**ZONING AMENDMENT
& SUBDIVISION STAFF REPORT****Date: November 6, 2008****APPLICANT NAME**

Grant Street East Subdivision

Southeast corner of Grant Street and Airport Boulevard

Subdivision approval to create a single lot of record from an existing metes and bounds parcel, and Zoning approval to rezone the site from R-1, Single-Family Residential, to T-B, Transitional-Business, to allow financial services offices.

SITE PLAN

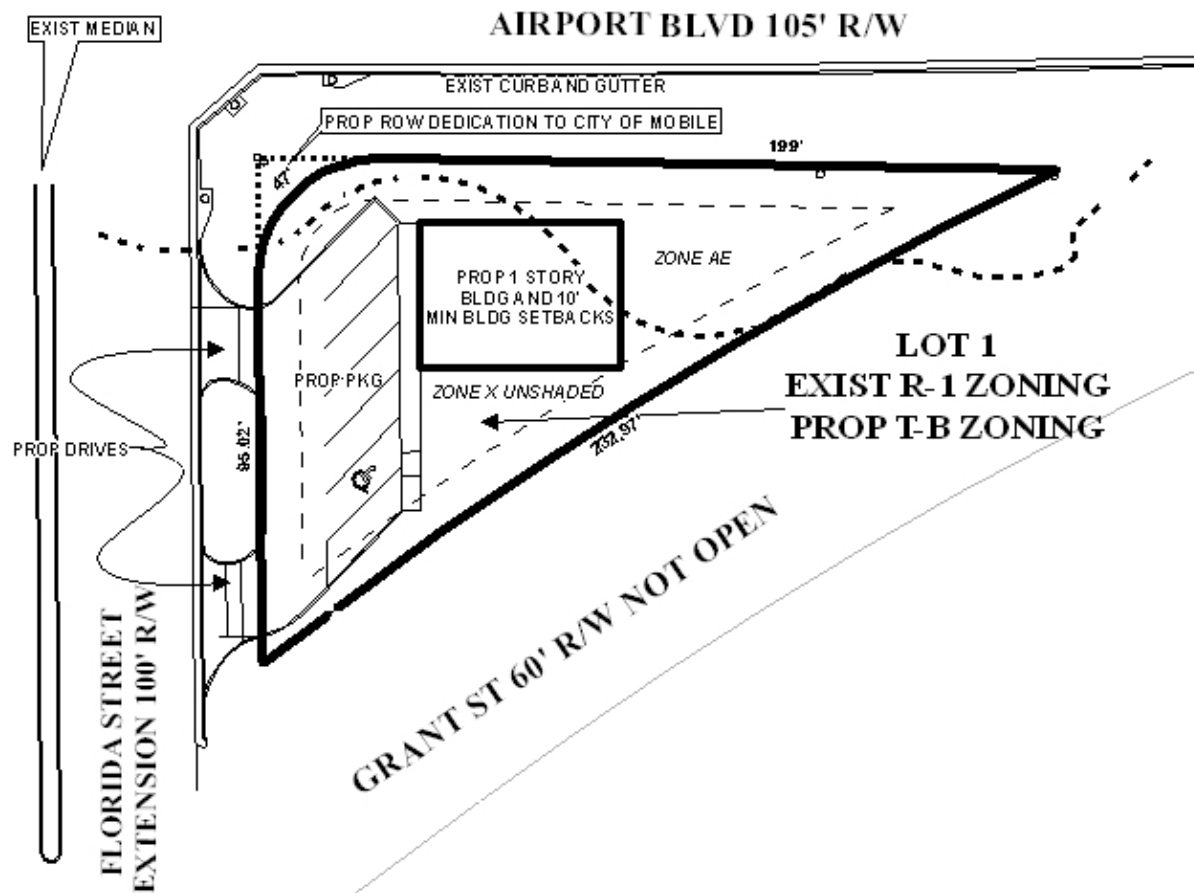
Driveway number, size, location, and design to be approved by Traffic Engineering and conform to AASHTO standards. Final approval for all driveways, proposed and existing will be given upon submittal of final plans. No details were given showing the driveway radii or connection to the right-of-way of either Florida Street Extension or Airport Boulevard. The angled parking does not provide adequate space for vehicles to maneuver. Changes should be made to accommodate the minimum standards required parking and driveway design.

Preservation status is to be given to the 48" Live Oak Tree located along the Airport Boulevard R/W near the proposed entrance. Any work on or under this tree is to be permitted and coordinated with Urban Forestry; removal to be permitted only in the case of disease or impending danger.

The applicant is proposing two one-way curb cuts onto Airport Boulevard and two one-way curb cuts onto Airport Boulevard. Due to the size and configuration of the property boundaries, access management is a concern. Airport Boulevard and Florida Street are both major streets with high traffic counts. The high traffic counts alone would be enough to warrant limiting, if not denying, access to Airport Boulevard and the Florida Street Extension. Additionally, the site has unique topographical concerns. Mainly, there is a 4 to 6 foot elevation change between Airport Boulevard and the property line, which would create line-of-site and safety concerns. For this reason, it is recommended that the site be denied access to both Airport Boulevard and the Florida Street Extension. The frontage along the unopened portion of Grant Street is adequate to allow two curb cuts.

The 25-foot minimum building setback is depicted on all street rights-of-way, and this should be retained in the final plat. Additionally, the size of the lot in square feet, or a note containing the same information, should be placed on the plat.

Urban Forestry has commented that there is a 48" Live Oak tree on the site that should be given preservation status. As the said tree was not depicted on the site plan, and given the limited

space already, the site plan may need to be revised to reflect the preservation status of this tree. Therefore, the site plan should be revised to reflect any changes which would result from the preservation of this tree.

A revised site plan, plat, and application were received. The applicant is now requesting rezoning from R-1, Single-Family Residential to T-B, Transitional Business. The applicant has revised the site plan to illustrate a single-story, 1,800 square foot building, with a single row of six angled parking spaces, with one way access to and from Florida Street Extension. The site plan also illustrates 10 foot setbacks from all rights-of-way consistent with Transitional-Business District regulations.

The applicant has removed the curb cuts from Airport Boulevard and indicated the 48” Live Oak Tree which has been given preservation status, all of which were consistent with staff recommendations. The applicant has also reduced the scope of his proposed building to one story.

The applicant continues to indicate one-way ingress and egress via Florida Street Extension. Traffic Engineering has approved this layout with stipulations. Because of the access management concerns with the site, the site should be limited to two one-way curb cuts or one two-way curb cut to Florida Street Extension and two curb cuts to the unopened Grant Street right-of-way; the site should also be denied access to Airport Boulevard.

- 1) Labeling of the size of the lot or provision of a table with the same information on the plat;
- 2) Revision of the plat to show a 25 foot setback from all street rights-of-way;

- 3) Placement of a note on the final plat limiting the site to one two-way curb cut or two one-way curb cuts to Florida Street Extension, with the size, location, and design of all curb cuts to be approved by Traffic Engineering and conform to AASHTO standards;

- 4) Placement of a note on the final plat limiting the site to two curb cuts to the unopened Grant Street right-of-way after such time that Grant Street has been constructed to city standards with the size, location, and design of all curb cuts to be approved by Traffic Engineering and conform to AASHTO standards;

- 5) Placement of a note on the final plat denying access to Airport Boulevard;
- 6) Placement of a note on the final plat stating that approval of all applicable federal, state and local agencies would be required prior to the issuance of any permits;
